APPLICATION FOR AMENDMENT
TO OPERATING LICENSE

Technical Specification
Page Revisions

Consolidated Edison Company of New York, Inc.
Indian Point Unit No. 2
Docket No. 50-247
Facility Operating License No. DPR-26
November, 1985

Safety Assessment

FIGURE 3.8-1
 LIMITING FUEL BURNUP VERSUS INITIAL ENRICHMENT

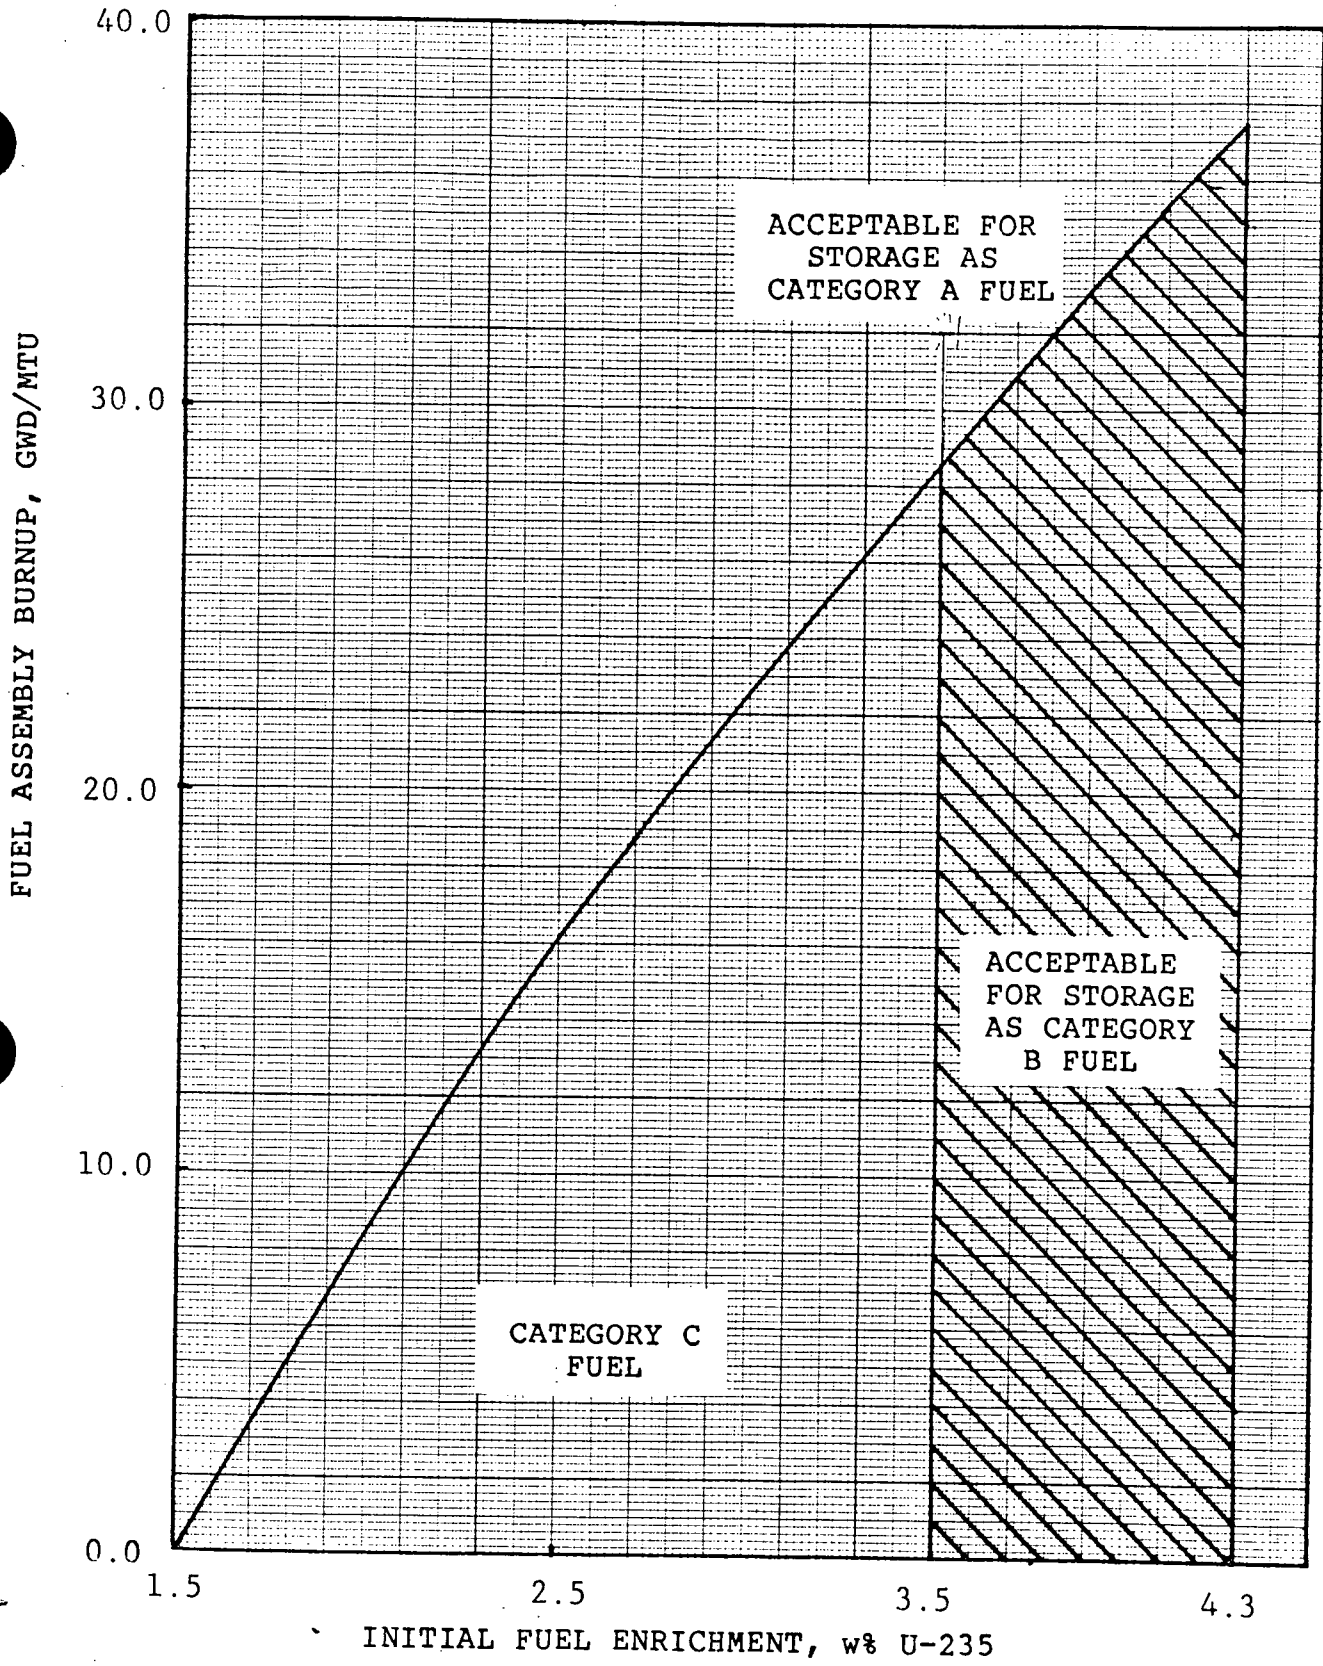
The fuel enrichment and burnup limits in Specification 3.8.C.1 assures the limits assumed in the spent fuel safety analyses will not be exceeded. Within this specification adjacent location means those four locations directly contacting the four sides (faces) of a fuel assembly but excludes those four locations which contact the four corners of a fuel assembly.

Technical Specification 5.3.A.3 is proposed to be revised to indicate that the reload fuel enrichment will be no more than 4.3 weight percent of U-235. Technical Specification 5.4.2 is proposed to be revised to indicate the fuel loading limits, corresponding to 4.3 weight percent of U-235, for the fuel racks for both new and spent assemblies. Technical Specification 3.8.C.1 is proposed to be included in order to incorporate the restrictions assumed in the analysis of Enclosure 1.

CATEGORY A - AREA ALONG THE CURVE AND ABOVE
 CATEGORY B - AREA BELOW THE CURVE AND $3.5 < w\% \text{ U-235} \leq 4.3$
 CATEGORY C - AREA BELOW THE CURVE AND $w\% \text{ U-235} \leq 3.5$
